2014 - 2015 Corvette: Service Bulletin: Creak or Snap Noise Above Windshield from Removable Roof Lift Off Panel While Driving

GM Bulletin No.: #15-NA-016

SUBJECT: Creak or Snap Noise Above Windshield from Removable Roof Lift Off Panel While Driving

MODELS: 2014 - 2015 Chevrolet Corvette

- (1) Example of a bad front locating pin.
- (2) Example of a good front locating pin.

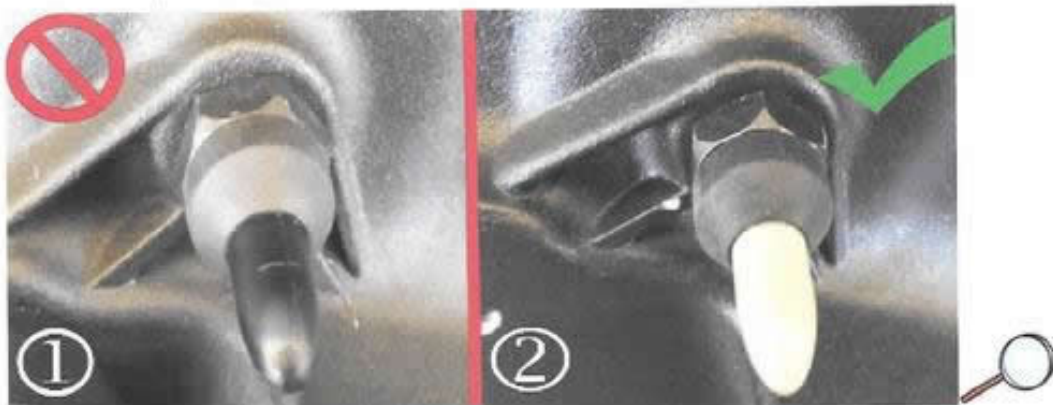
CAUSE: This may be caused by a stick-slip condition between the front latches against the strikers and the front locating pins to the locating cup in the strikers.

If you encounter a vehicle with the above concern, replace both the front roof lift off panel strikers and both front locating pins. Refer to Roof Lift Off Panel/Window Front Striker Replacement and Removable Top Locating Pin Replacement in SI.
